Model	RDH for F410	Volt/Hz	Date of Modification	Serial Number
Modified Article	Parts Catalog			
Reason for Modification	Parts catalog correction

Model	RDH for F410 / 420	Volt/Hz	Date of Modification	Serial Number
Modified Article	Idle Roller Arm			
Reason for Modification	To prevent incorrect original size detection

Model: RDH for F410/420	Date: 22-Mar-00	No.: MA378010
-------------------------	-----------------	---------------

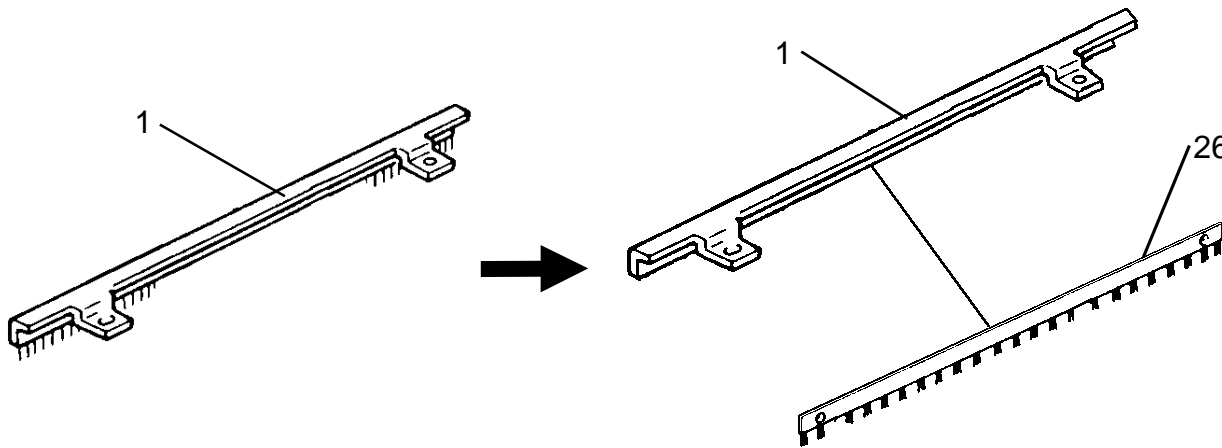
Please correct your parts catalog as follows:

New P/N	Description	Q'ty Used	Parts Catalog	
				Index No.	Page
Incorrect	A4992338	Antistatic Brush Plate	1	1	17

* New Index No.

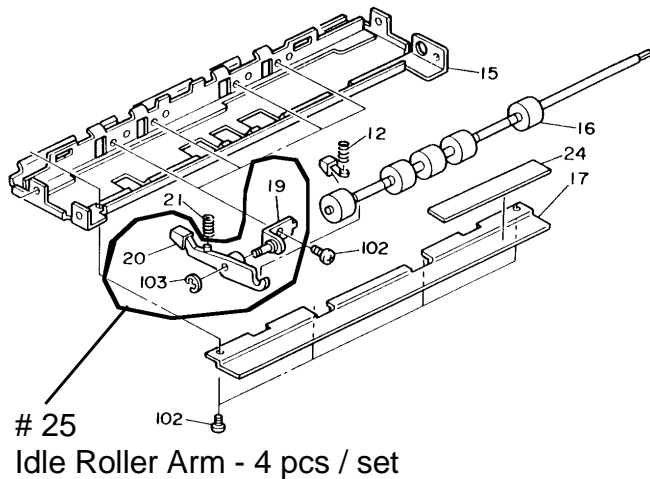
To prevent incorrect original size detection, the shape of the idle roller has been changed.
 For details, please refer to F400 RTB - 019.

Old P/N	New P/N	Description	Q'ty Used	Inter-changeability	Parts Catalog	
					Index No.	Page
A4991361	A3781397	Bracket - Idle Roller Arm	4 → 0		19	9
A4991365		Idle Roller Arm	4 → 0		20	9
07200030E		Retaining - M3	n → n-4		103	9
		Idle Roller Arm - 4pcs / set	0 → 1	X/O	* 25	9

* New index number

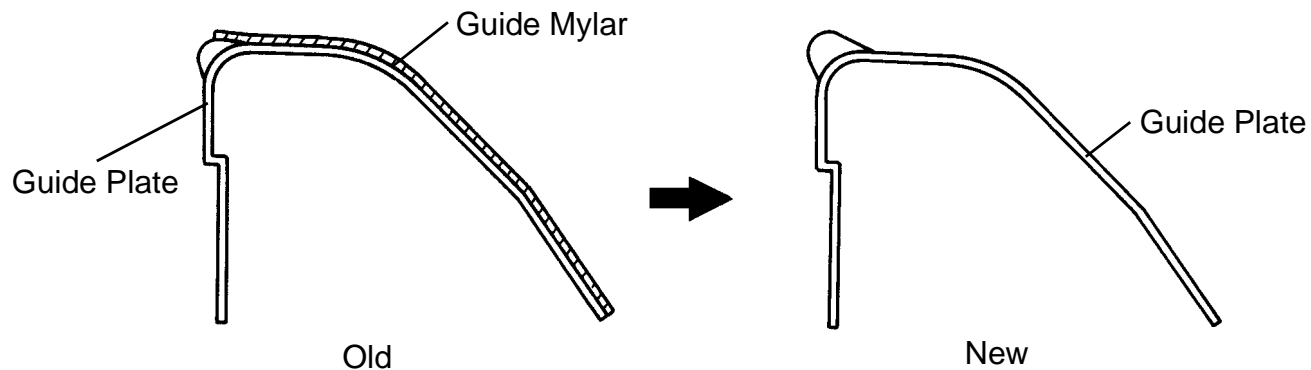
To facilitate manufacturing, the shape of the guide plate has been changed and the guide mylar has been removed.

Old P/N	New P/N	Description	Q'ty Used	Inter-changeability	Parts Catalog	
					Index No.	Page
A4992198		Inverter Guide Plate	1 → 0	X/O	4	15
	A3782198	Exit Guide Plate	0 → 1

DETAILS OF MODIFICATION

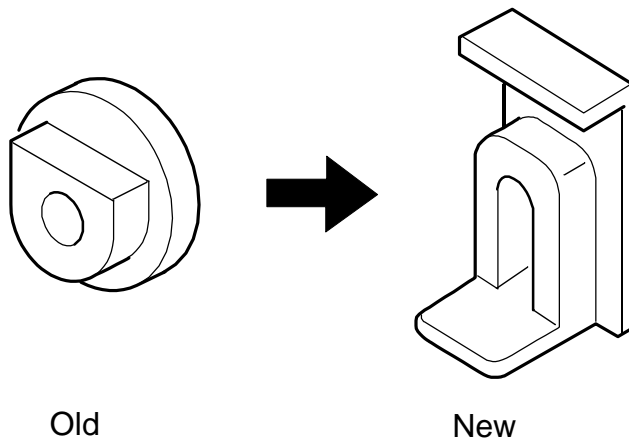
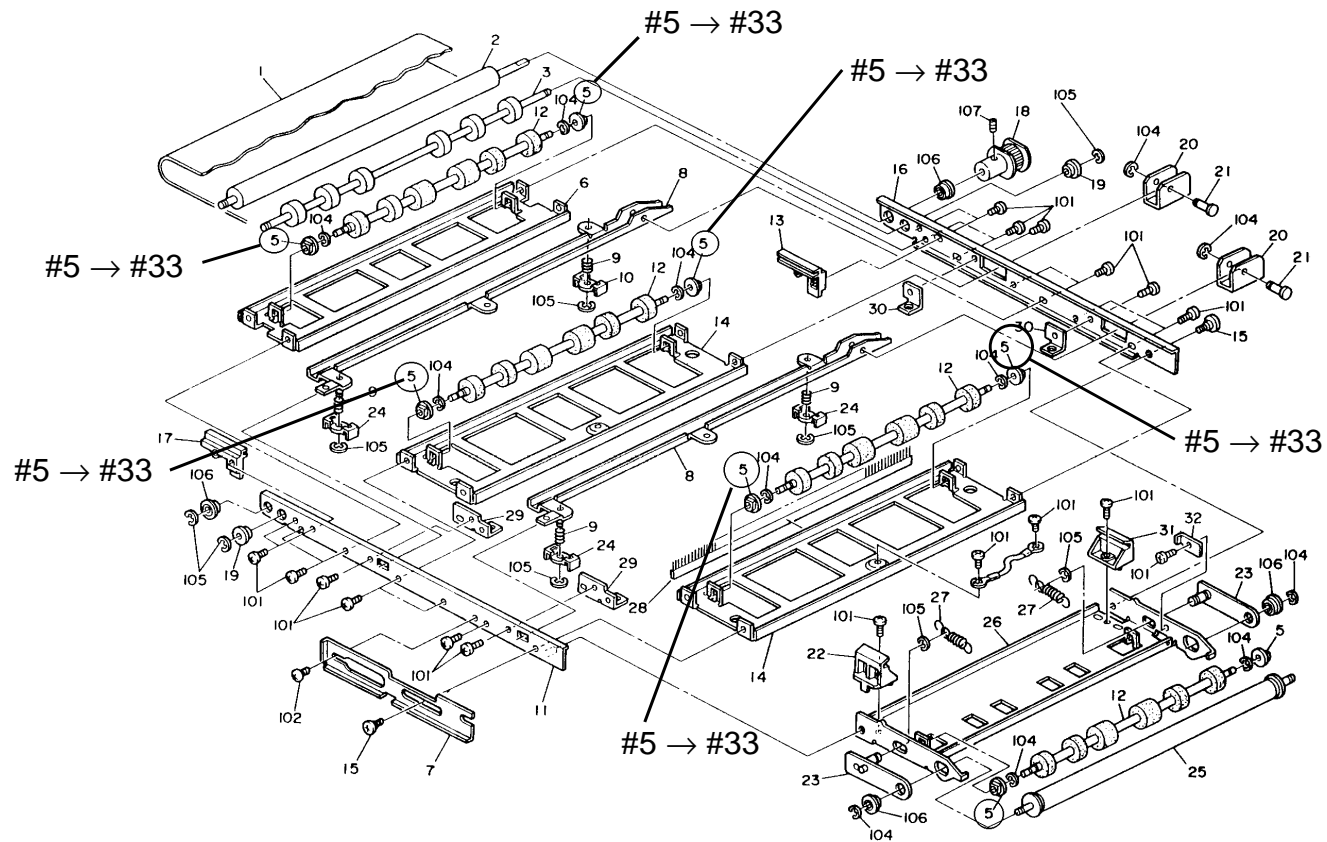
Old P/N	New P/N	Description	Q'ty Used	Inter-change-ability	Parts Catalog	
					Index No.	Page
A4991616		Bushing - 4 mm	8 → 2	X/	5	11
	A3781616	Pressure Roller Busing	0 → 6	/O	* 33	11

To improve durability, the shape of the bushings have been changed as shown.

DETAILS OF MODIFICATION

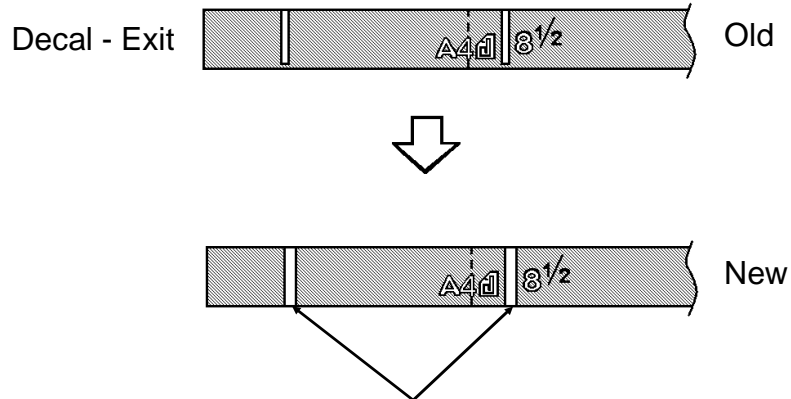
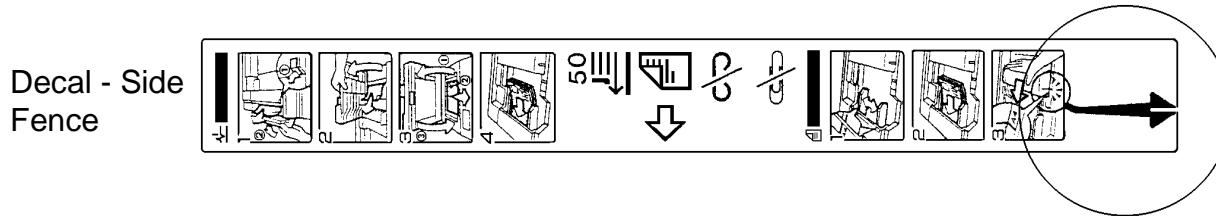
If the user does not adjust the exit unit position correctly, a jam or an original order mix-up may occur. A large arrow has been added to the side fence decal and the alignment lines on the exit decal have been enlarged as an enhanced instruction to users.
